**TOTAL SYSTEM PERFORMANCE ASSESSMENT ISSUES IDENTIFIED BY THE
U.S. NUCLEAR REGULATORY COMMISSION (NRC)**

ENCLOSURE 1

Response to Specific Questions

in
NRC Letter of May 17, 2001
on TSPA Quality Issues

Figure 1. Distribution from SR00_037ne6.gsm file (Creep_Used_BIN4)

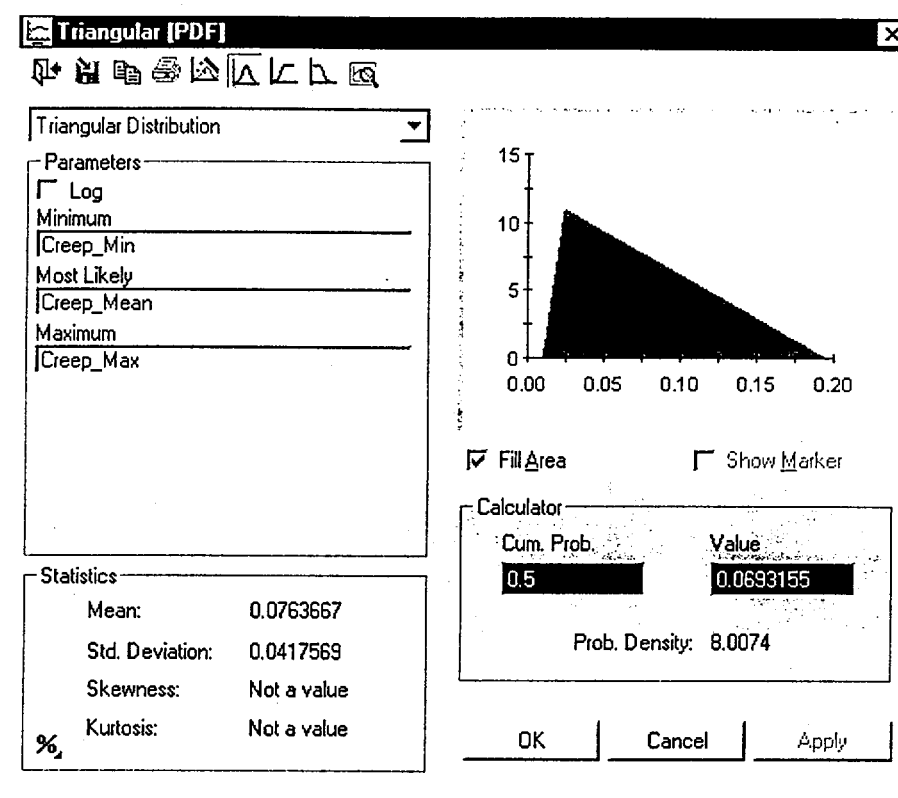
NRC QUESTION: The last paragraph on page 285 states, "Table 6-45 (linearly interpolated between points) is used to define the creep failure distribution (triangular) with the minimum equal to 0.0105, the mean equal to 0.0244, and the maximum equal to 0.1942." However, the triangular distribution in GoldSim uses the minimum value, maximum value, and most likely value, not the mean. It is not clear whether this problem represents a numerical problem, or if there are errors in the documentation and the checking of the documentation.

The information in the TSPA-SR Model Report appears to be incorrect. If the documentation is accurate with the description of the distributions by the minimum value, maximum value, and mean, then there may be a numerical error as discussed below.

If the mean is 0.0244, the peak of the distribution is at -0.1315. As shown in figure 1, the peak lies outside the range represented by the minimum and the maximum values. When parameters are sampled from such a distribution, values outside the range will have two probabilities of occurrence. One value cannot have two different probabilities of occurrence from any distribution function.

DOE RESPONSE: The document incorrectly uses the term "mean" rather than the correct term "most likely" with respect to the triangular distribution for the fraction of rods perforated from creep (Table 6-45 and page 285) and the unzipping uncertainty multiplier (*Unzip_uncert*, page 288). The input triangular distributions use minimum, most likely, and maximum values. As noted in the text (page 285), the median value for the triangular distribution for the fraction of rods perforated from creep is 0.069 at temperatures less than 177 C. The TSPA-SR model files

(GoldSim files) use the distribution correctly, as intended by the supporting AMR. The documentation will be clarified in a subsequent revision.

The correct distribution for the fraction of rods perforated from creep at peak waste package surface temperatures less than 177 C are illustrated below. Figure 1 is derived directly from the input file used to create the Nominal Scenario Base Case Median Value Simulation (SR00_0037ne6) while Figure 2 is a generic triangular distribution with the same minimum, most likely, and maximum values. [NOTE: Even though the value used for the "most likely" parameter is called 'Creep_Mean', it correctly represents the "most likely" value of the triangular distribution.]

Figure 2. Distribution from a Generic GoldSim File

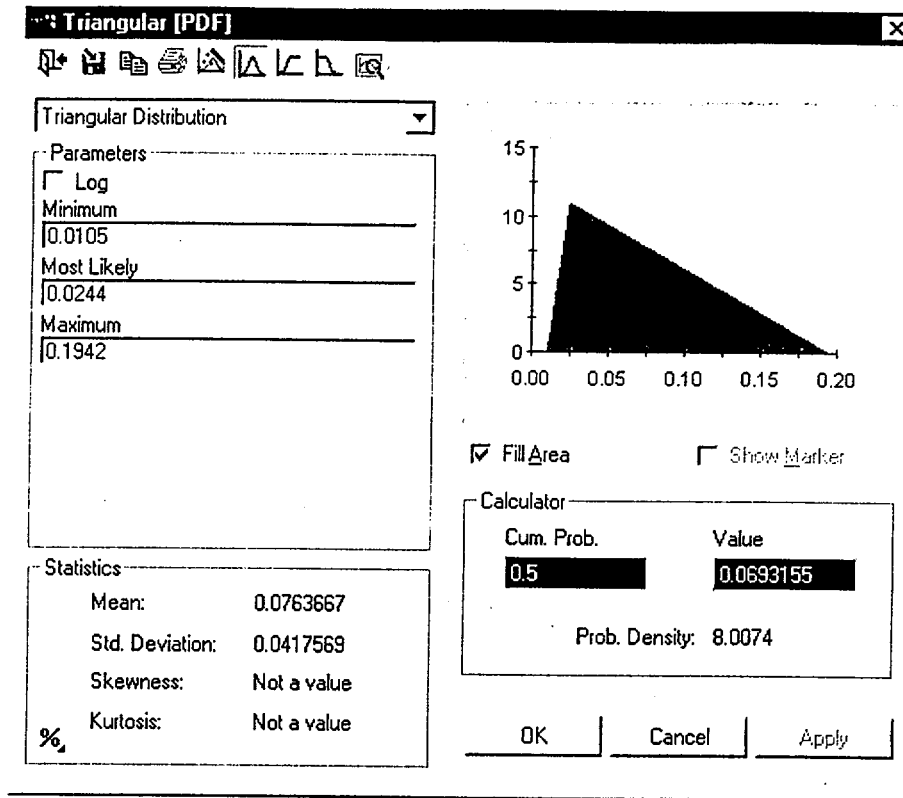
Similar arguments can be made to show that the peak for the triangular distribution presented on page 288 (*Unzip_uncert*, is defined as a triangular distribution with a minimum equal to 1, a mean equal to 40, and a maximum of 240) has a peak that lies outside the range (i.e., peak is at -121).
